**CITY OF TEMPE
DEVELOPMENT REVIEW COMMISSION**

**Meeting Date: 03/03/2015
Agenda Item:**

ACTION: Request for Development Plan Review of a new sanctuary and parish house for Iglesias De Dios Pentecostal Church located at 906 South George Drive. The applicant is Rene Rivera, 3R Construction Group.

DPR14132 Development Plan Review including site plan, building elevations, and landscape plan

SANCTUARY ELEVATIONS

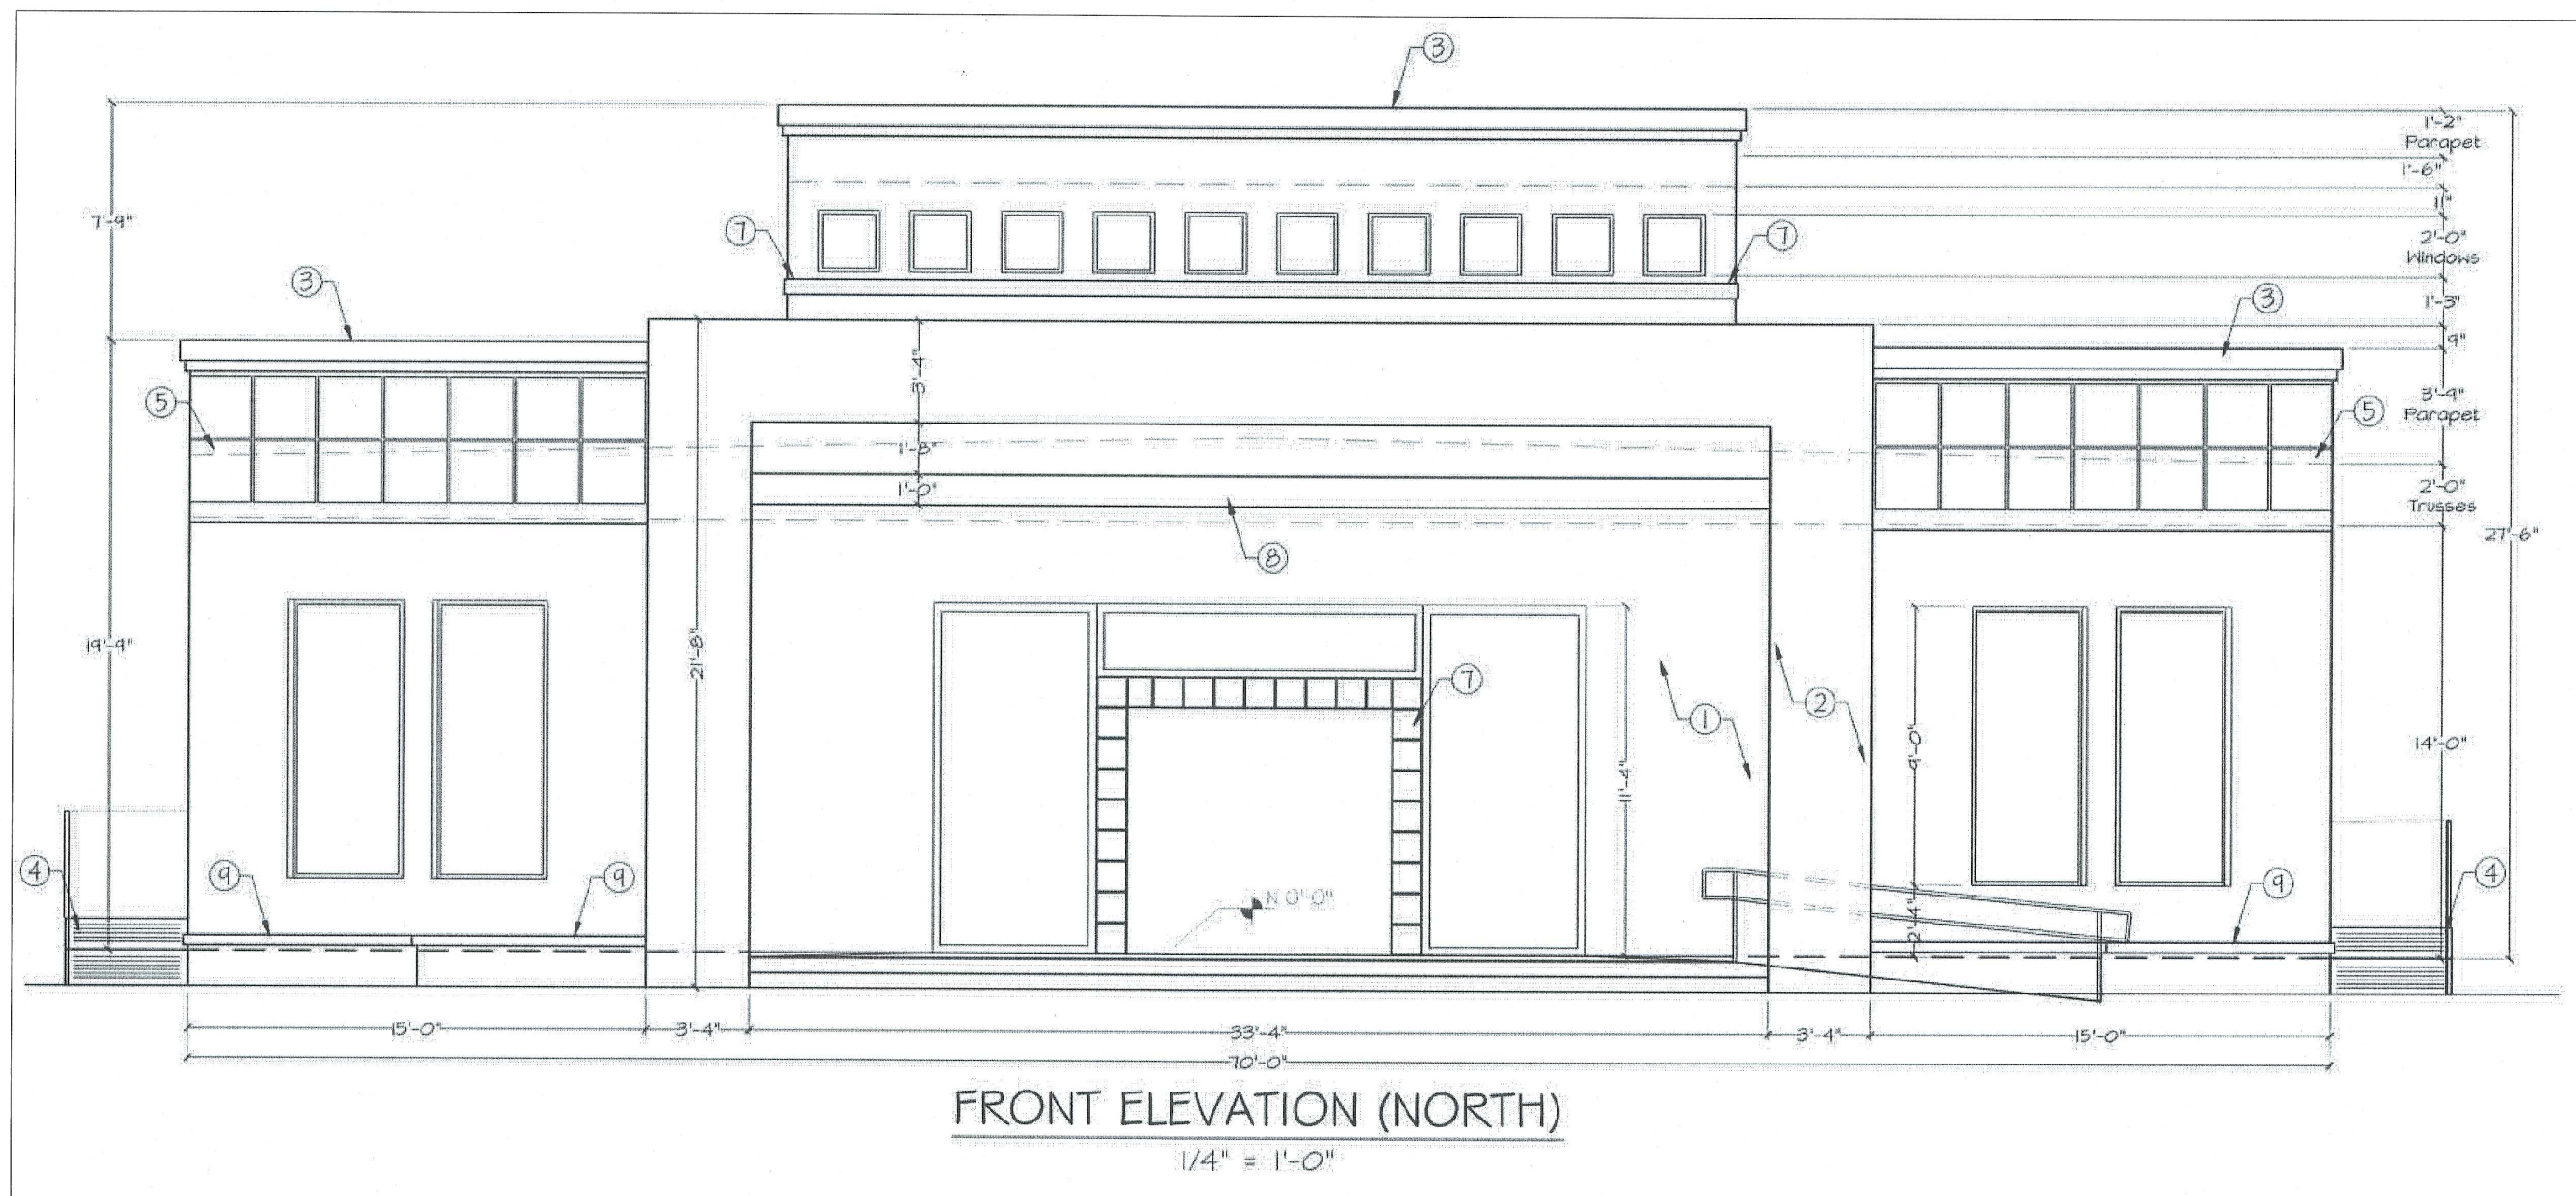
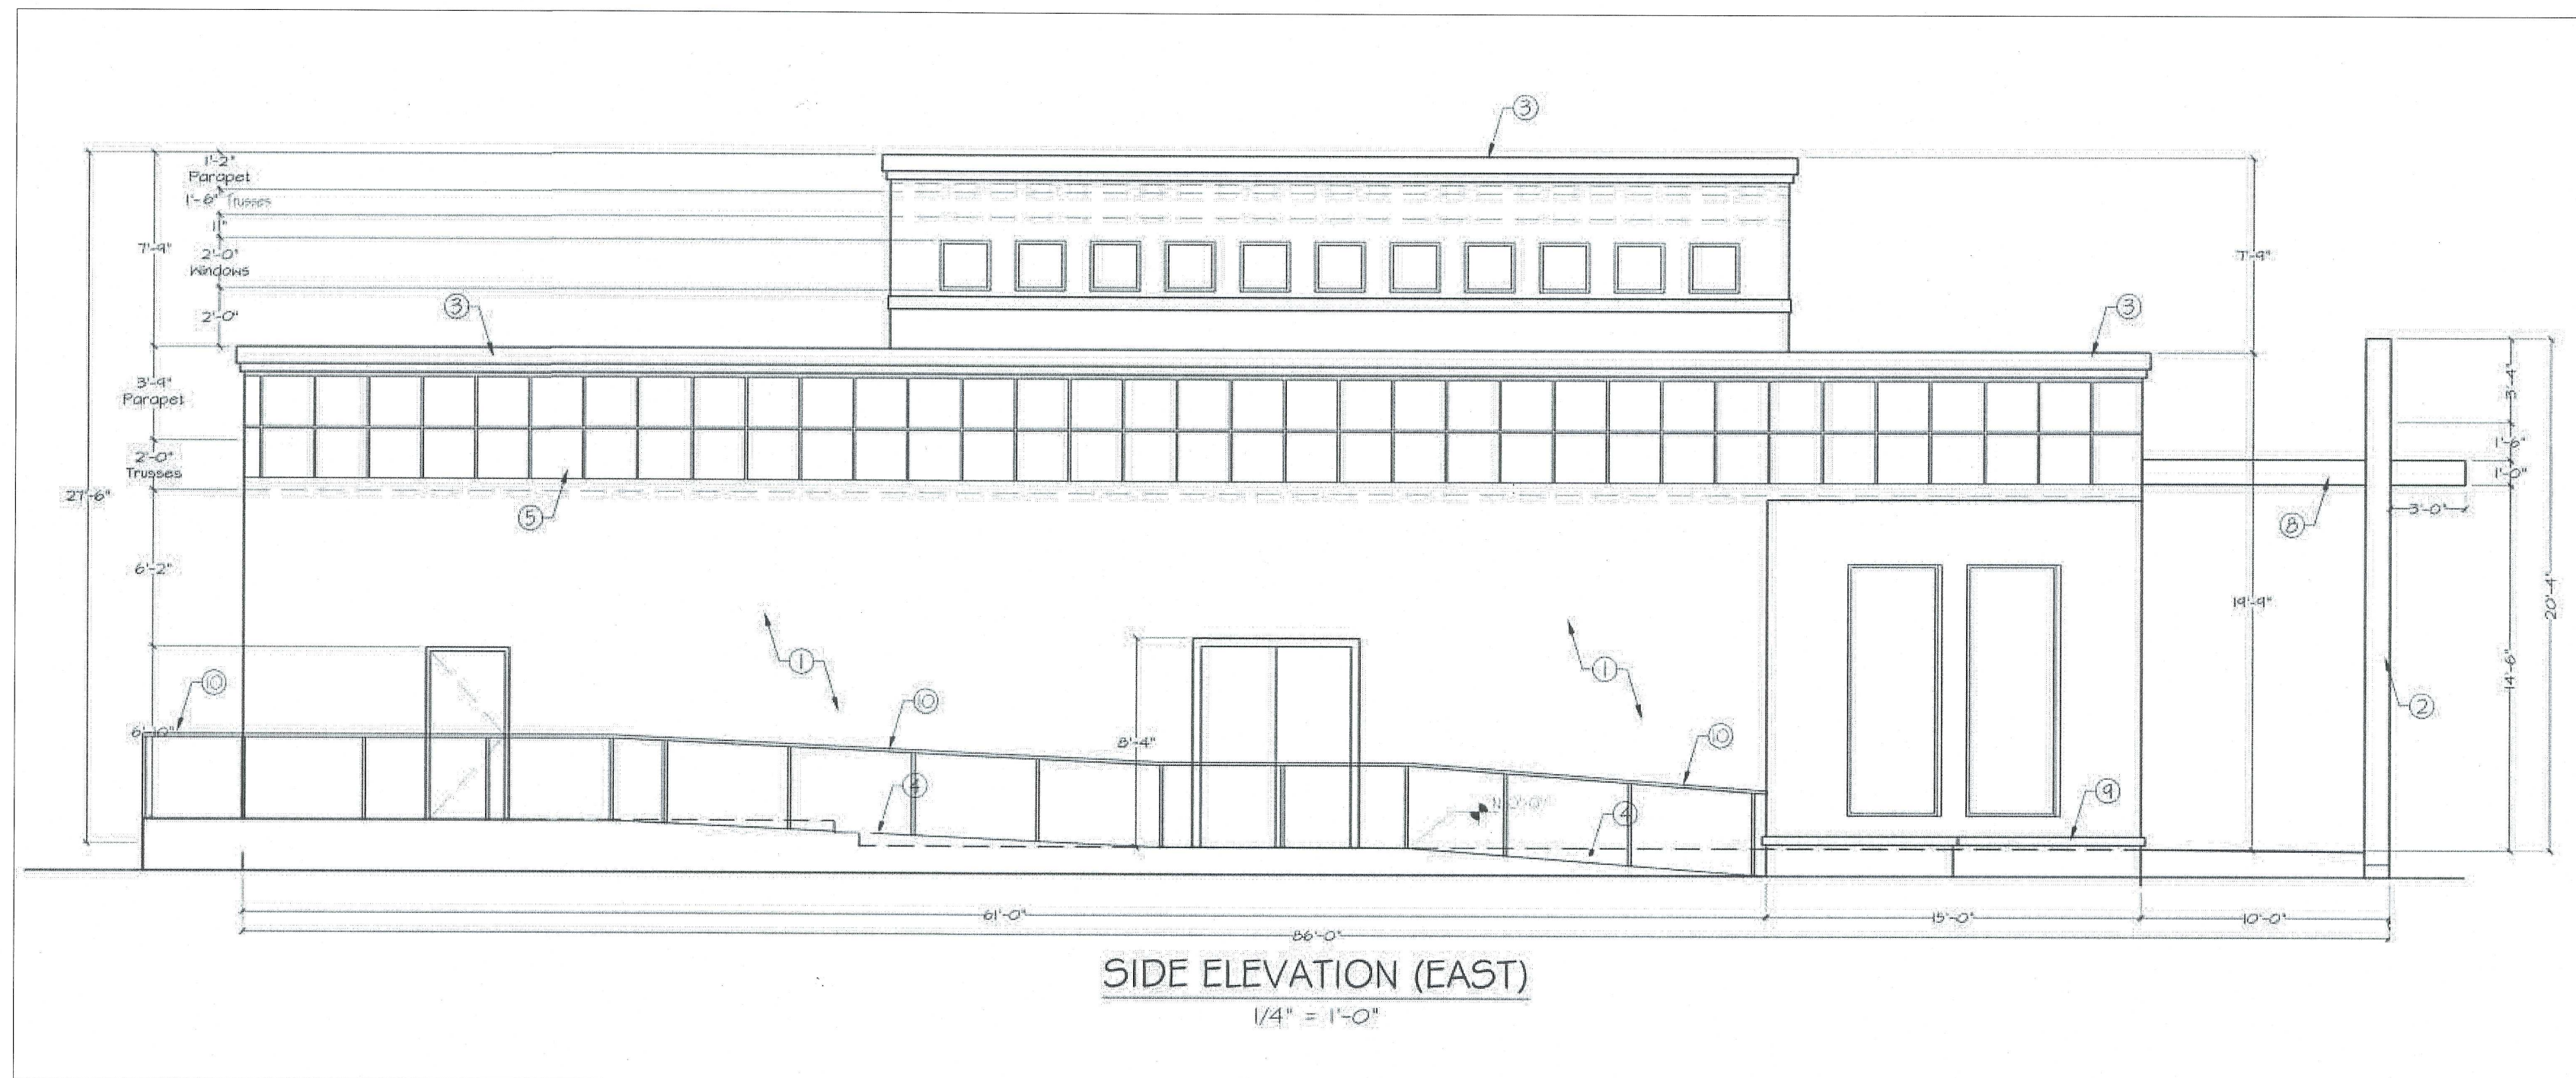
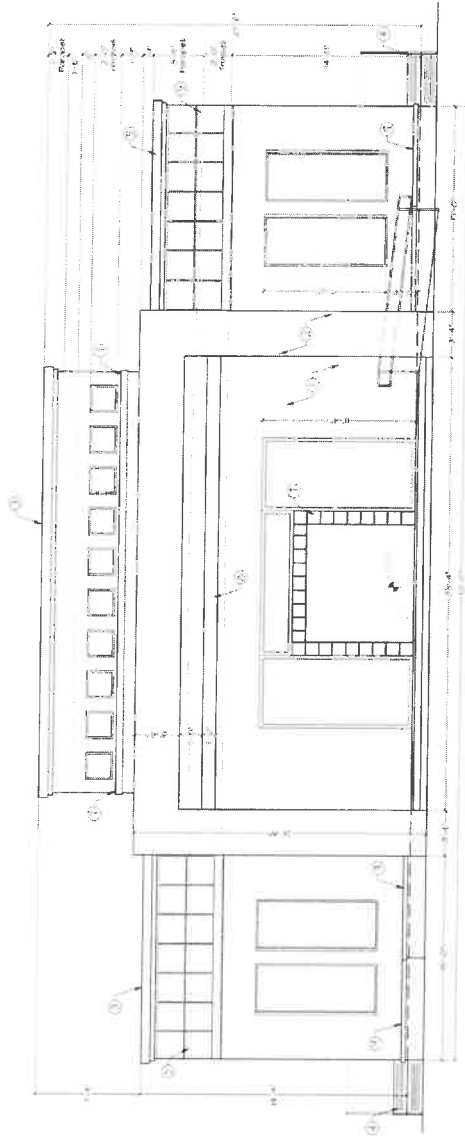
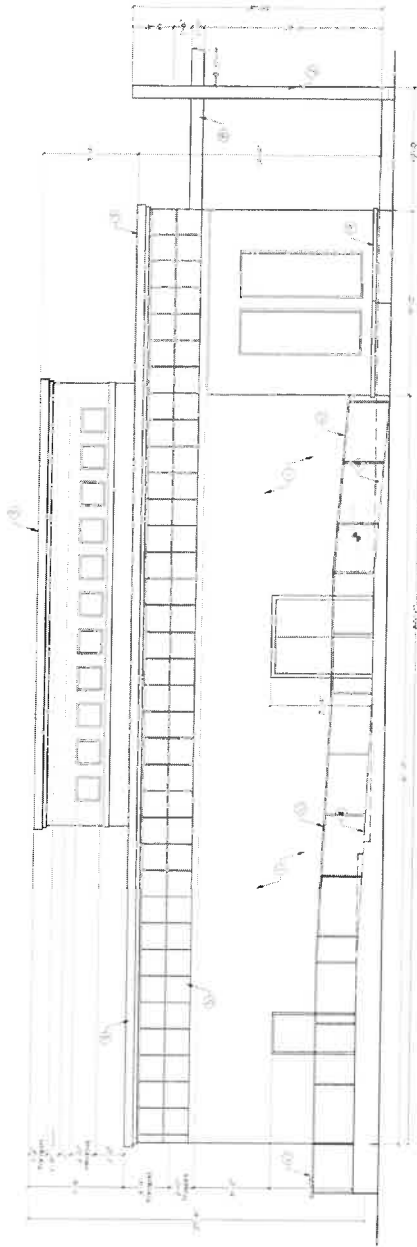
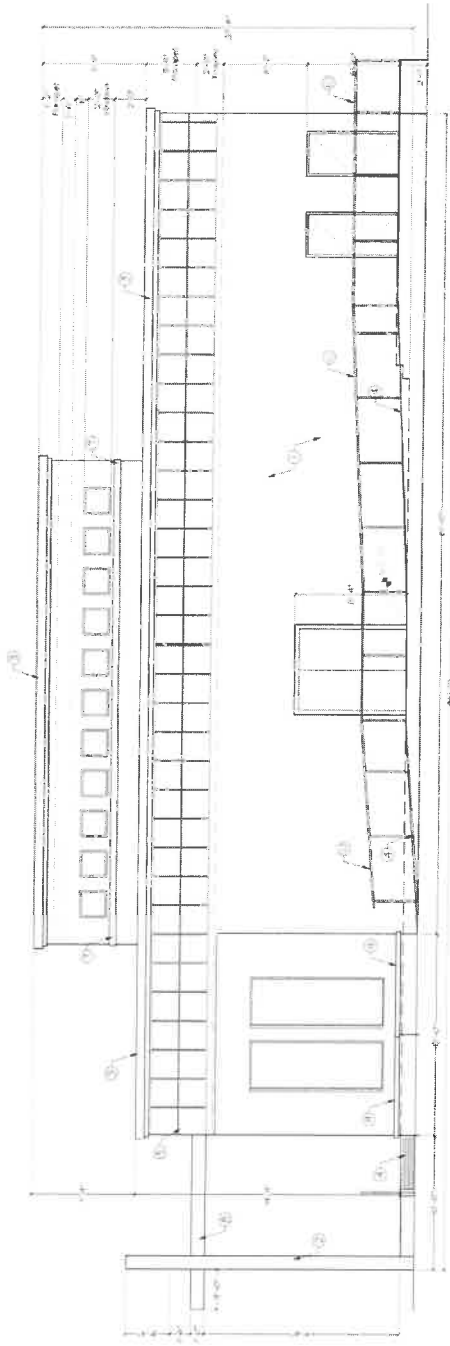
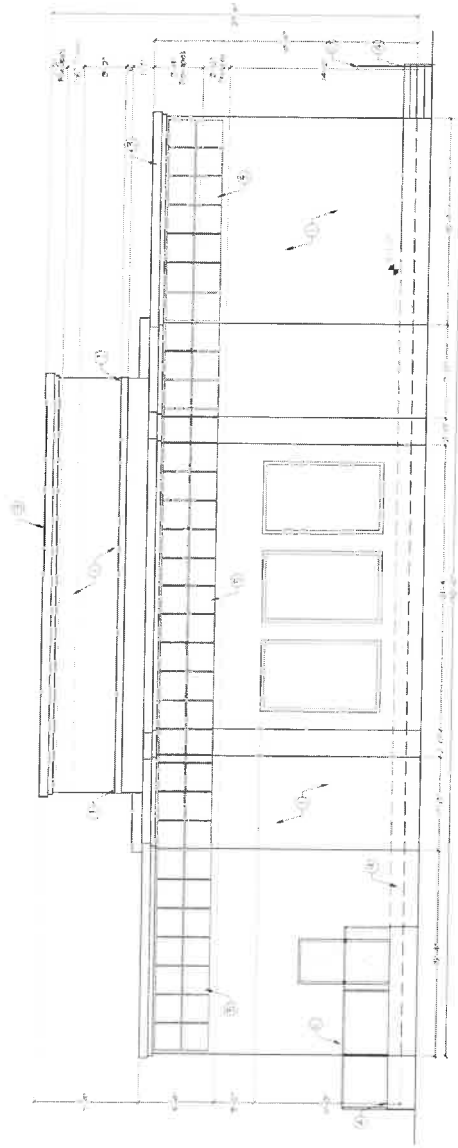
The building has been designed for visual prominence at the entrance. The elevation features a defined base the masonry and top created by the raised element with a sloped roof with clearstory windows. The simple building mass is well articulated and features a well-defined base and top. The vehicular as well as pedestrian experience in the public right of way adjacent to the site is enhanced by the building, site and landscape design.

8. Existing building to be painted to match new color scheme of Sanctuary and Parish House
9. Incorporate lighting, address signs, and incidental equipment attachments (alarm klaxons, security cameras, etc.) where exposed into the design of the building elevations. Exposed conduit, piping, or related materials is not permitted.
10. Locate the electrical service entrance section (S.E.S.) inside the building or inside a secure yard that is concealed from public view.
